FINAL
ENVIRONMENTAL STATEMENT
Related to the Proposed
SEABROOK STATION
Units 1 and 2

SEABROOK STATION
UNITS 1 AND 2

PUBLIC SERVICE COMPANY OF NEW HAMPSHIRE

DOCKET NOS. 50-443 and 50-444

Fig. 2.3. Land use plan. Source: ER, Sect. 2.1, Fig. 2.1-4.

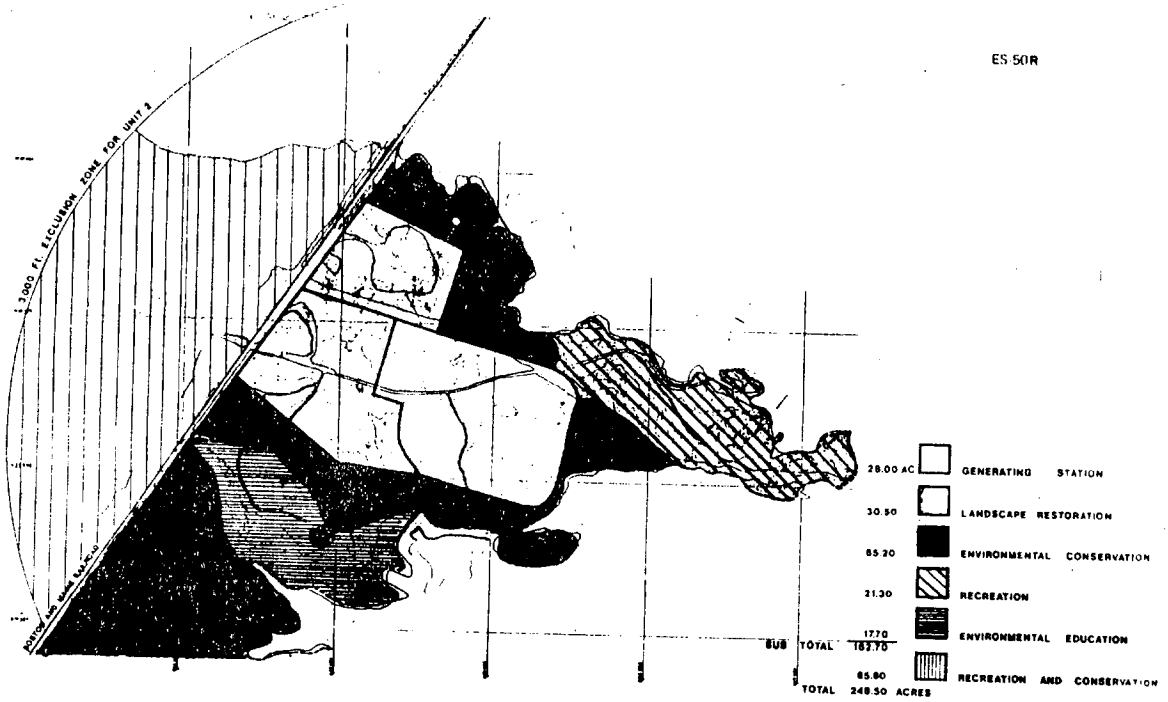
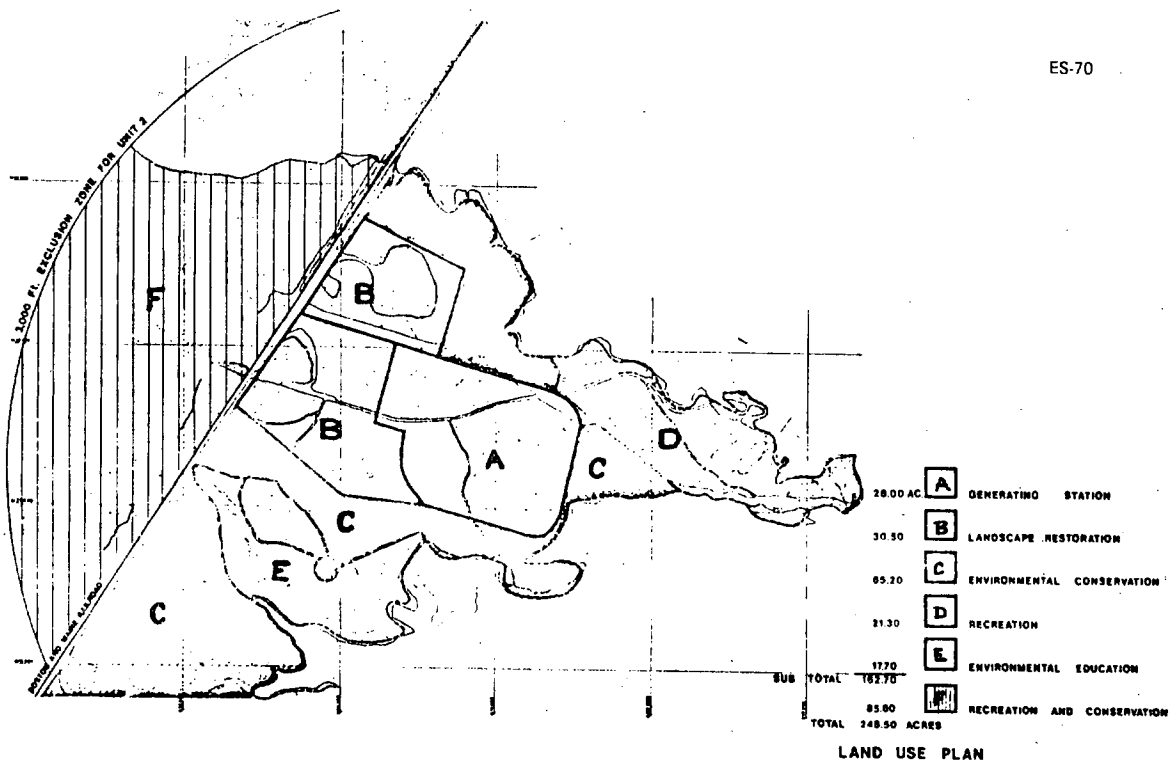
Of primary interest to us are the applicant's plans regarding use of lands and associated water under its control not needed for power generation and ancillary facilities. A land use plan is represented by figures 2.3 and 4.1, but these drawings do not include any discussion of that plan. By their inclusion in the draft environmental statement, figures 2.3 and 4.1 imply a commitment by the applicant of roughly 190 acres of its land holdings to public recreation or other public use activities. To clarify this matter, we suggest that the final environmental statement include a thorough discussion of the applicant's contract study entitled, "Land Planning and Site Design Study," conducted by KLING/PLANNING (Appendix I of the environmental report). The discussion should include such matters as:

Fig. 3.3. Plant water use diagram. Source: ER, Sect. 3.3, Fig. 3.3-1.

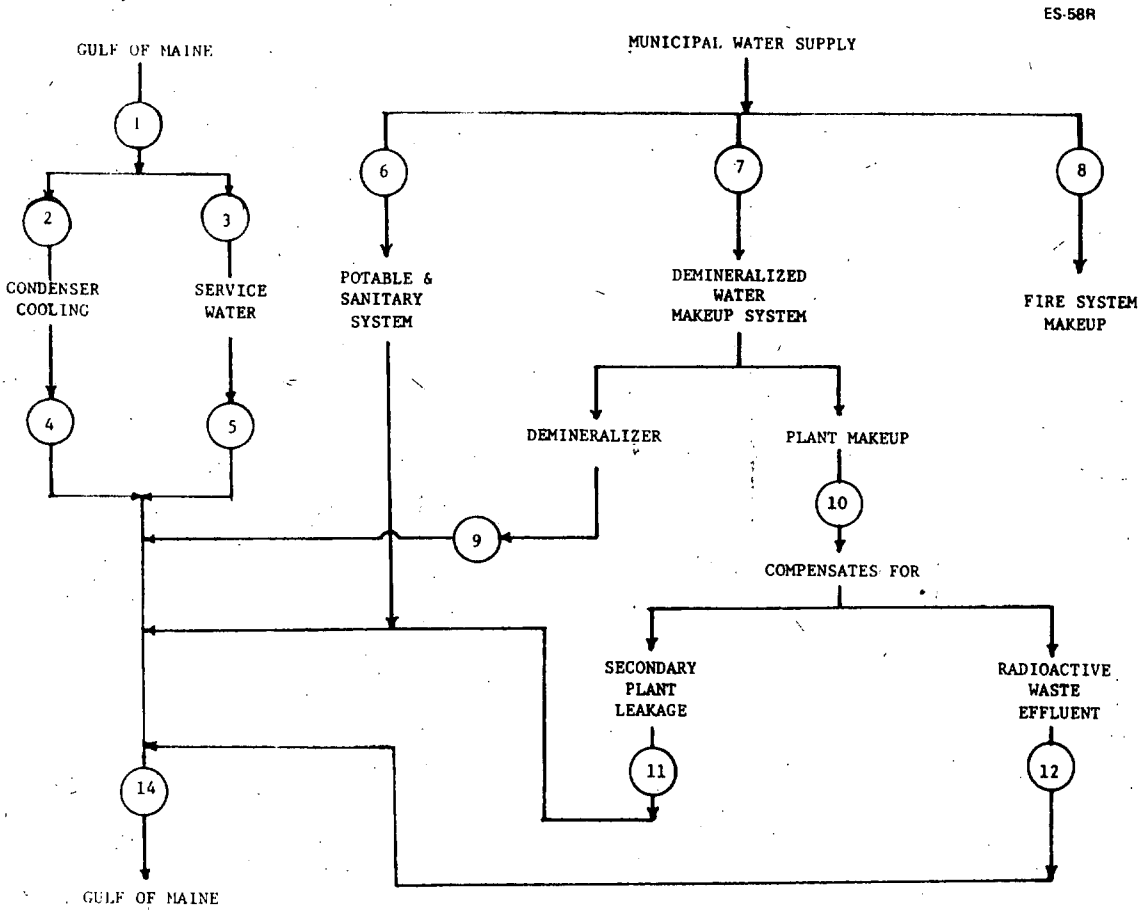
Attention is directed to revised information in Environmental Report Section 3.3-1 which revises Draft Environmental Statement Figure 3.3. The information is repeated below for convenience. Secondary plant leakage is directed through an oil separator before going to the circulating water discharge.

Fig. 3.14. Gaseous waste treatment systems.

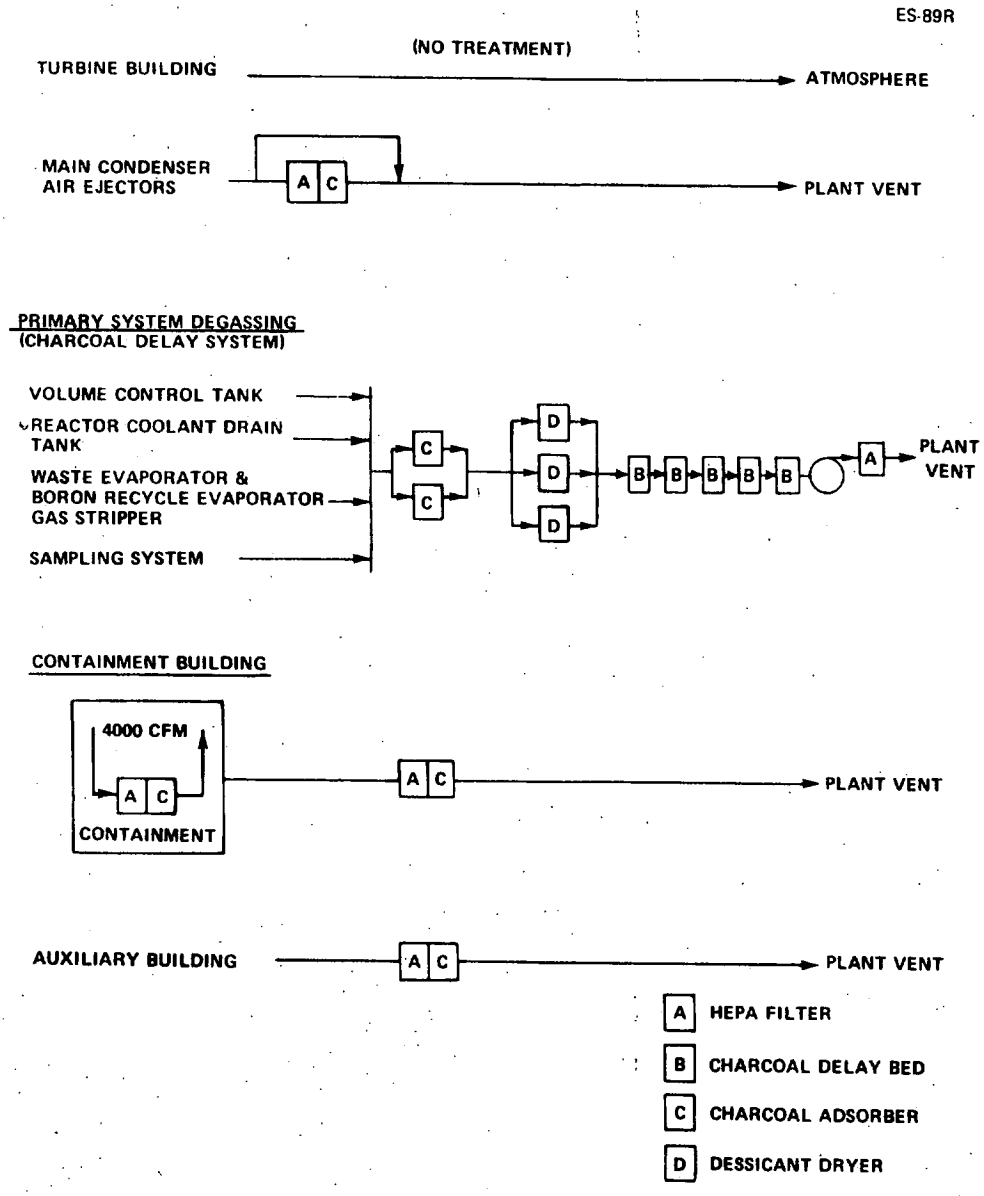
Fig. 3.14 Diffusers not determined or effects established. Release of Gaseous waste after 90 day hold up calculations of GWPS releases to be 1000 Ci/year Reactor for noble gases and negligible for Iodine. Plant Operators estimates 4380 Ci/year reactor of noble gases released from GWPS.

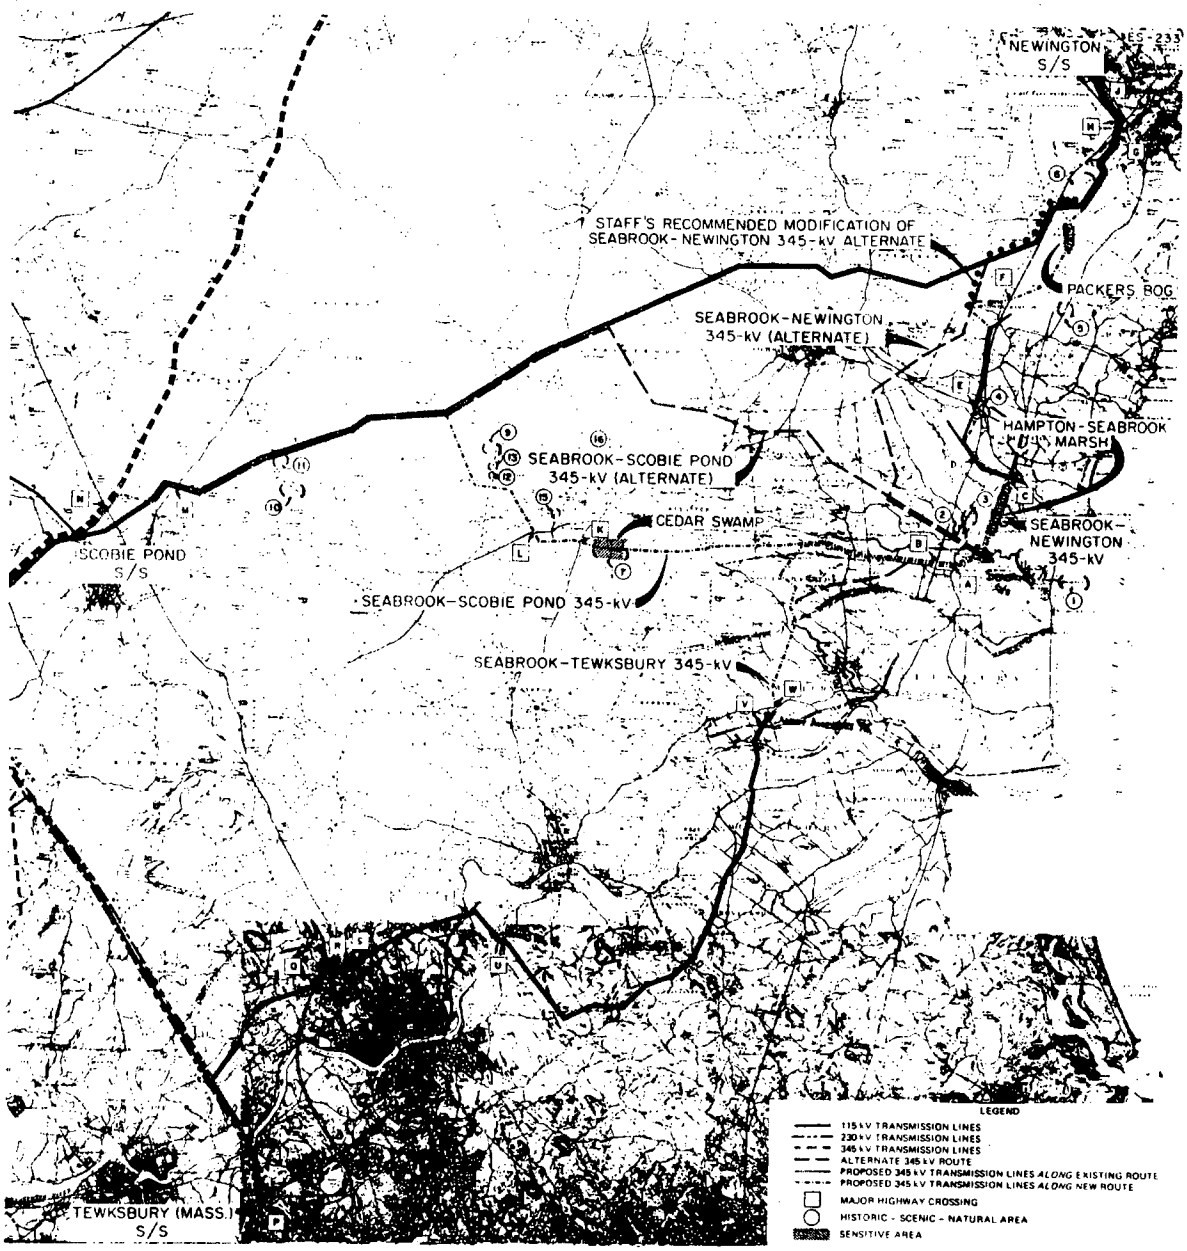
It is unclear whether the "transmission additions" noted in Figure 3.15, Page 3-31 of the DES are in addition to the initial lines proposed for Seabrook 1 and 2. The matter should be clarified for two reasons:

The staff considers that successful location of Seabrook lines along alternate routes as presented in Fig. 3.15 can be effected through careful and thoughtful right-of-way planning and utilization of environmentally acceptable clearing and facilities construction practices. Notwithstanding other possible conflicts as may arise, the staff considers preservation of the integrity of the Cedar Swamp natural area, in concert with removal of any threat of construction of overhead transmission lines across sections of the Hampton-Seabrook marsh, sufficient compensation for any additional costs likely to be incurred in implementing required alternatives.

Fig. 4.2. Aerial photograph of Cedar Swamp environs showing approximate locations of applicant's initial selection, "alternate B," and the staff's required modification for routing the Seabrook-Scobie Pond line. (Prepared from PSNH blueprint, Appendix K, and photograph supplied by R. King, SPNHF.)

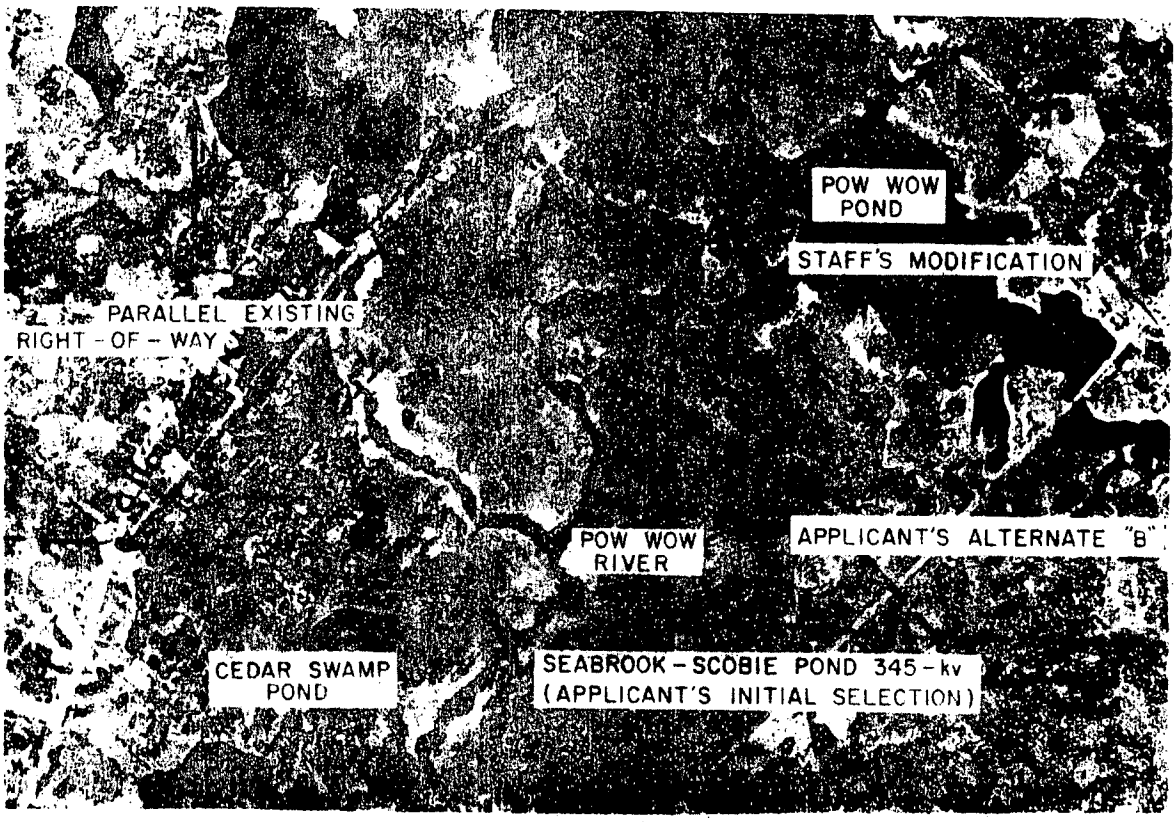
In terms of effecting such a requirement, the staff has considered a modification of the applicant's "alternate B" ("staff modification," Fig. 4.2). The plan as presented involves relocating the Seabrook-Scobie line further to the north, as compared with the applicant's proposal. Such relocation extends to a greater radius around the sensitive Cedar Swamp-Pow Wow wetlands complex and parallels the existing transmission corridor along substantial portions of eastward segments.

A comparison of conductor lengths and right-of-way requirements for the several plans presented in Fig. 4.2 are given in Table 4.3. Implementation of the staff's modification to "alternate B" requires an increase of 42 acres for right-of-way and approximately 1.3 miles of conductors with supporting structures, compared with the applicant's original "straight-line" routing. The staff considers that this small increase in transmission facilities is justified in order to prevent serious degradation of physical, visual, and biological aspects of the Cedar Swamp environs as shown in Fig. 4.2.

Fig. 5.3. Summary of chlorine toxicity data on marine life.

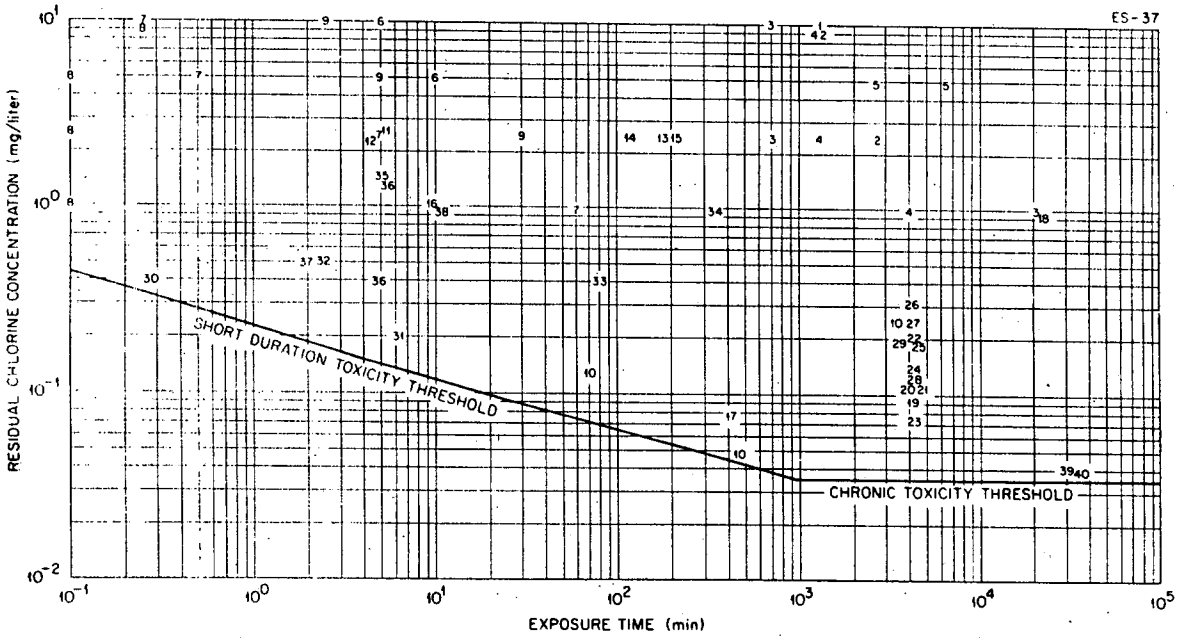
The Applicant notes that the form of the chlorine has not been expressed in this part. The Applicant suggests that all chlorine concentrations be expressed in $mg/_l$ as hypochlorous acid for free available residual chlorine. Otherwise, the possibility of confusion and misinterpretation exists over the values of concentration. This comment applies especially to Figure 5.3 and Table 5.9.

Fig. 8.3. Historic and predicted annual peak demands for the New England Power Pool.

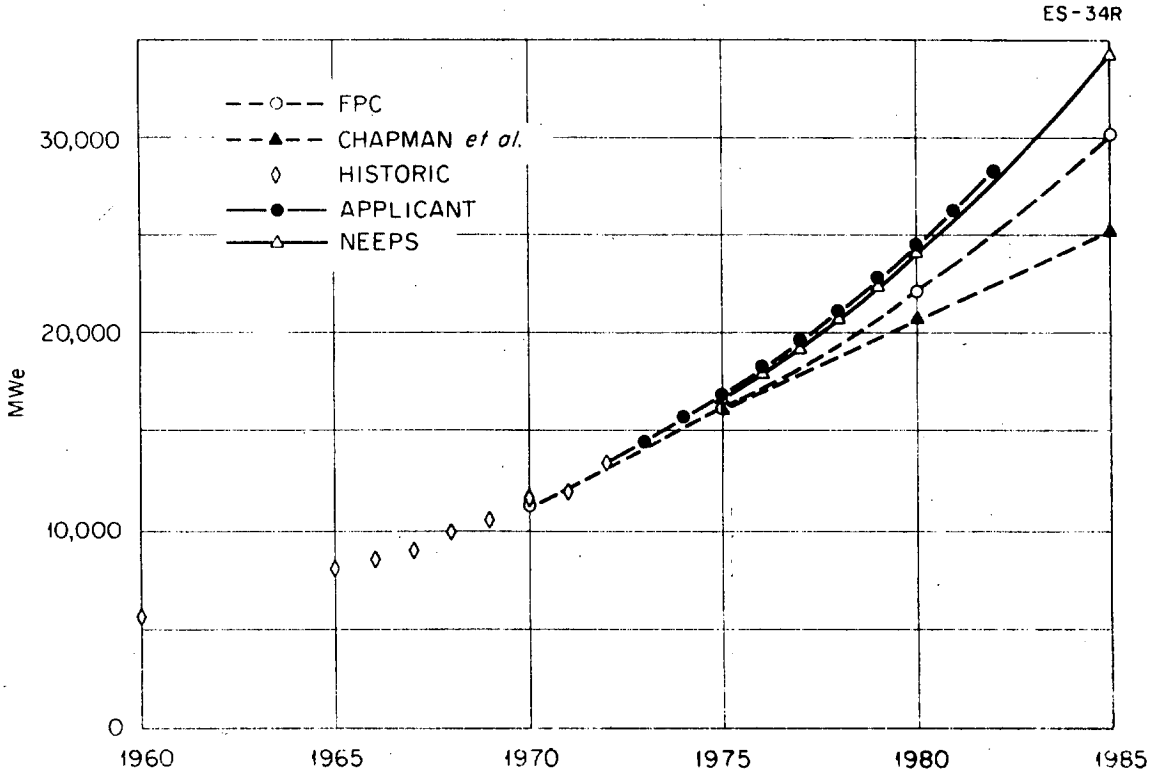
Without attempting to give any indication of the validity of the low side projection of annual peak demands for NEPOOL set forth on Figure 8.3, Public Service records that it seriously questions the validity of using electricity demand projections by Chapman, Tyrell and Mount as a proper basis for New England energy forecasting. It is our observation that elasticity studies prepared by these authors are based on questionable assumptions and data, and that use of these studies may lead to incorrect conclusions and public policy.

The draft EIS does go so far as to illustrate this point in figure 8.3. However, that figure cannot be regarded as a projection which accounts for the price effects since we don't know what price changes are incorporated therein; it is merely an illustration of the direction of the effect, not the magnitude.

Fig. 9.3. Transmission line alternate route No. 2. Source: ER, Fig. 10.9.2.

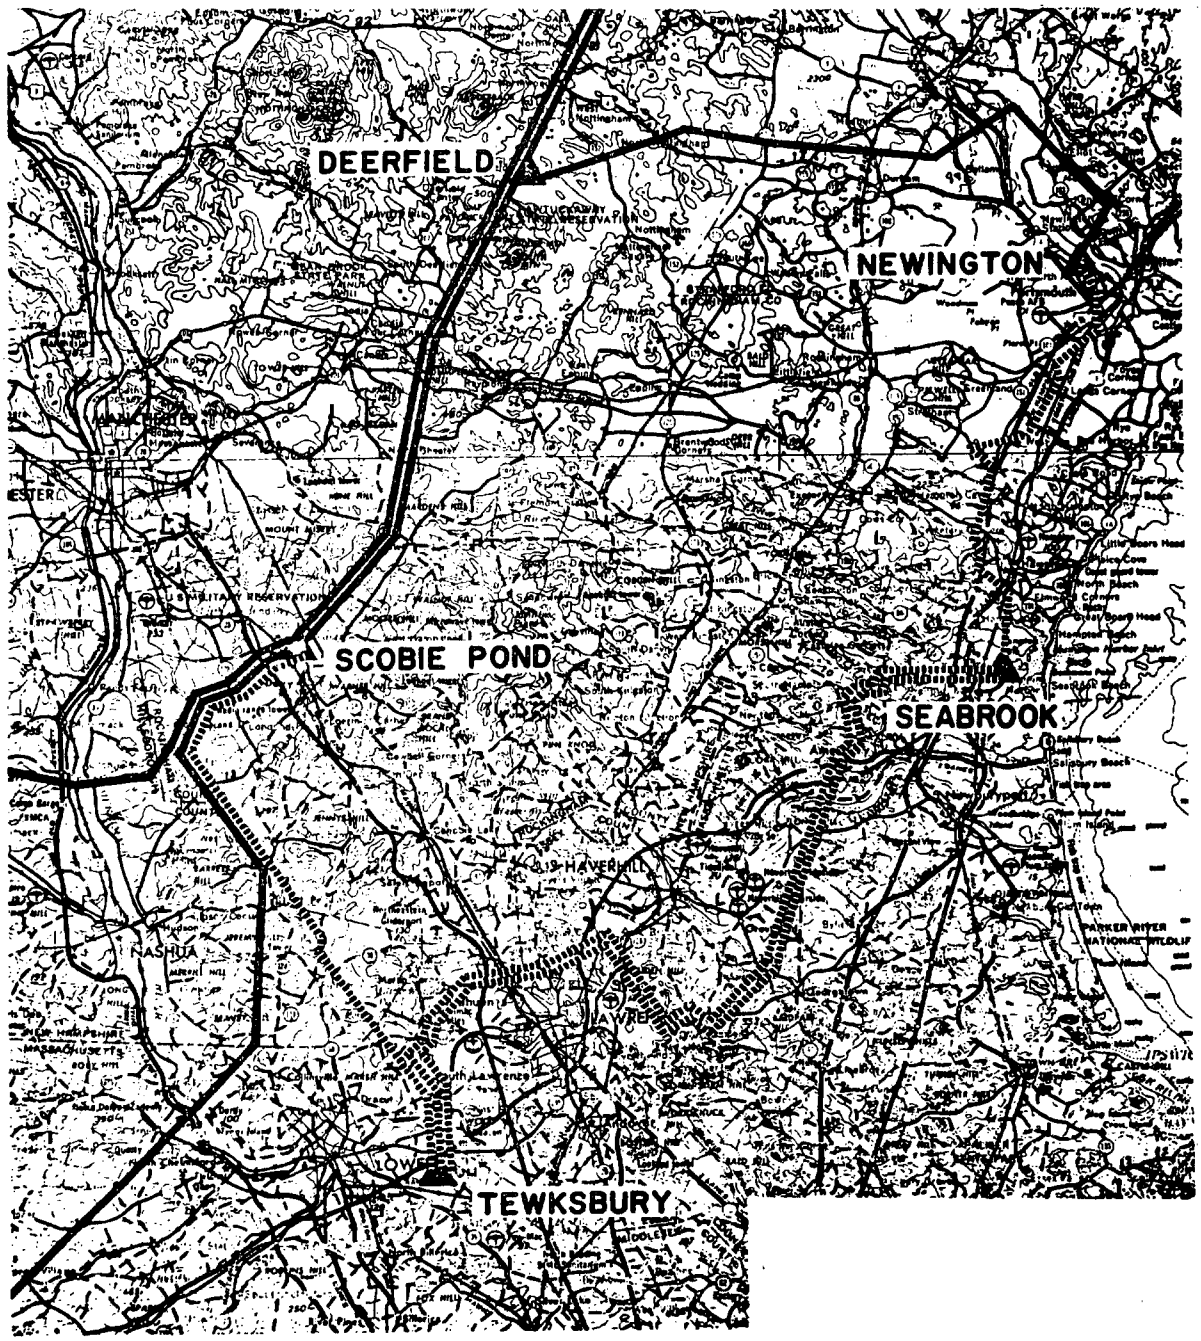
Stability studies show that the transmission system route recommended by the Staff and shown in Figure 9.3 of the Draft Environmental Statement for Seabrook Station Units 1 and 2 has an extremely deterimental affect on system reliability. If this routing is required the line cannot be terminated at Tewksbury as first proposed, since additional studies indicate that the line must be continued to Sandy Pond Substation at Ayer, Massachusetts. Figure A4.1-2 shows the additional line. The alternate route requested by the Staff will now require approximately 35 miles of additional 345 KV transmission line.
